**DEPARTMENT OF TRANSPORTATION**

**Denial of Petition for Rulemaking; Federal Motor Vehicle Safety Standards Rear Impact Guards**

**ACTION:** Denial of petition for rulemaking.

FIGURE 2. GUARD ENERGY ABSORPTION  
(TYPICAL FORCE-DEFLECTION CURVE AT P3)

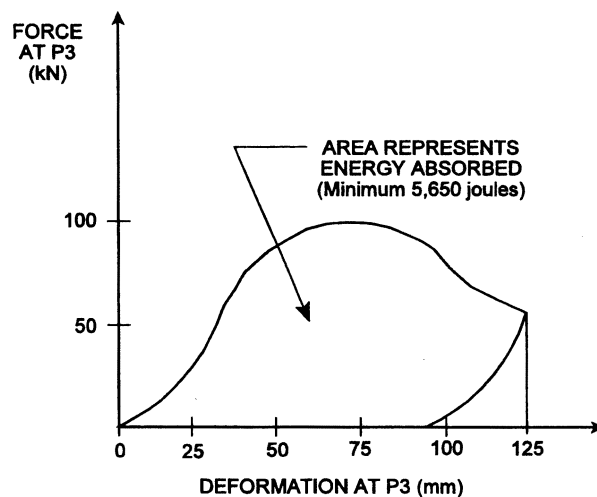
TTMA wants the test procedures revised to specify that the energy absorption test ends before 125 mm of displacement "if 5,650 J of energy absorption has been exceeded." TTMA contends that if the minimum amount of energy absorption required by S6.6(c) has been exceeded during a displacement of less than 125 mm, "and little elastic rebound is anticipated," it is not necessary to fully displace the guard to 125 mm as currently specified in S6.6(c). TTMA presumably believes

TTMA's suggested revision is not practicable. As noted earlier, the amount of energy is determined by calculating the area enclosed within the force deflection curve, and the elastic rebound (the small triangle in the lower right of the figure above) is not counted. When we conduct compliance testing, it is impracticable for us to predict the amount of elastic rebound that a given guard design will exhibit. While in some cases a premature end to the test might produce a force-deflection curve with enough area enclosed within it to pass the test, in other cases, it might not. If we ended the test prematurely and the guard unexpectedly exhibited excessive elastic rebound, it might not pass the test. In this case, we would need to conduct another test, pushing the guard to the full 125 mm in order to eliminate the possibility that the guard would experience more plastic deformation during the final centimeters, causing it to rebound less after the force was

Moreover, basing a test procedure on assumptions that we make during a particular test would not meet the statutory requirement that our standards be objective. The required performance level must be based on a specific test procedure in order to be objective.

deflected by the full 125 mm. Therefore, a manufacturer could reasonably certify compliance based on a test that was ended prior to its completion. However, we will follow the test procedures in the FMVSS when conducting compliance tests. Further, the 125 mm requirement was specified based on the energy absorption of a NHTSA designed and built complying guard when subjected to a dynamic crash of a vehicle colliding with the guard at 48 kph (30 mph). Changing the test conditions would result in compromising the level of protection of the occupants of the colliding vehicle.
